MONTGOMERY COUNTY HISTORIC PRESERVATION COMMISSION
STAFF REPORT

| Address: | 12 Montgomery Ave., Takoma Park | Meeting Date: | 3/2/2022 |
| Proposal: | Solar Panel Installation and Roof Replacement | | |

Figure 2: Shade report for the subject property.

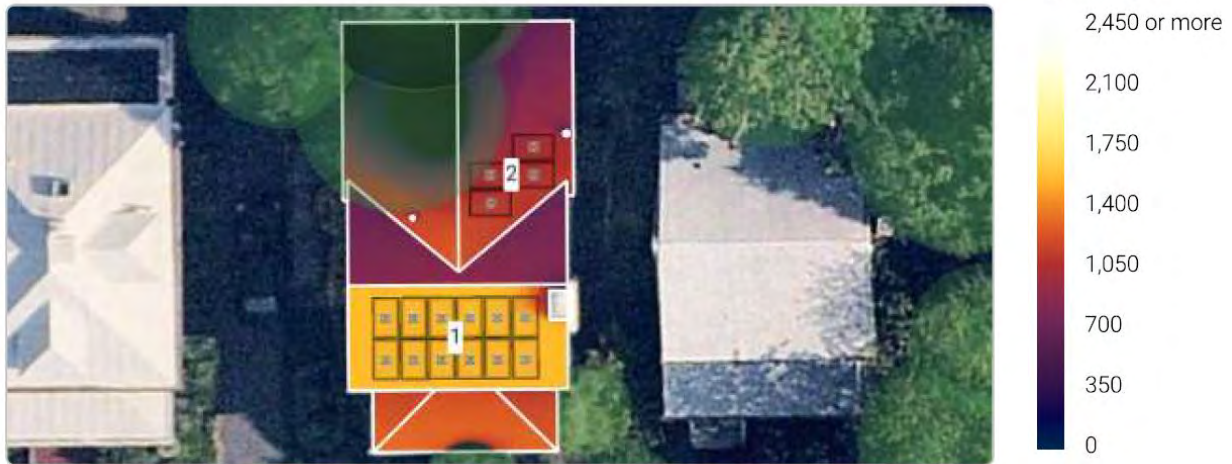
The applicant proposes to install 12 (twelve) solar panels on the front (south) facing roof slope in a 2 × 6 configuration. Installing solar panels on the front roof slopes is generally a disfavored location unless the applicant can demonstrate that no other location is sufficient. Staff finds that a ground-mounted array is not feasible, because of the size of the subject property and the trees in the rear of the property.

The calculations provided by the applicant show that the proposed configuration would offset 97% (ninety-seven percent) of the household's energy use.

Figure 3: Alternative array configuration without front-facing panels.

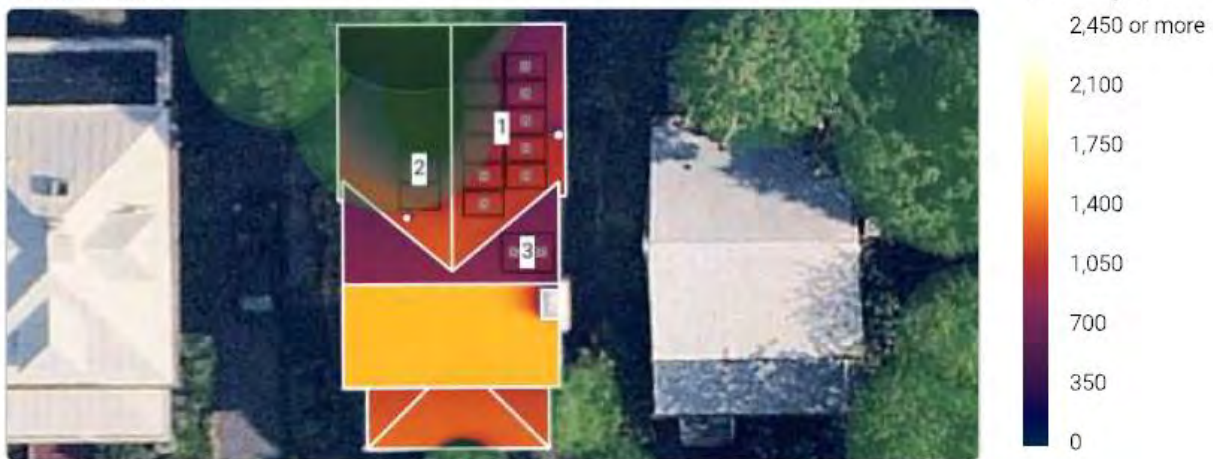
In response to questions from Staff, the applicant produced an alternative array that eliminates any front-facing panels. None of the panels in this configuration would be visible from the public right-of-way. The alternate configuration has the same number of panes, 16 (sixteen), as the proposed array but would only offset 43% (forty-three percent) of the household's energy usage. The payback period for this configuration is nearly four times longer than the proposed array.

Staff finds that the all-rear configuration presented demonstrates that, due to the resource's orientation, front-facing panels are necessary for adequate solar collection. Staff further finds that the side gable roof, which lacks dormers or an interior chimney, is not architecturally significant; and that the proposal will not impact any historic fabric. Based on these findings, Staff recommends the HPC approve the proposed solar installation under 24A-8(b)(6).
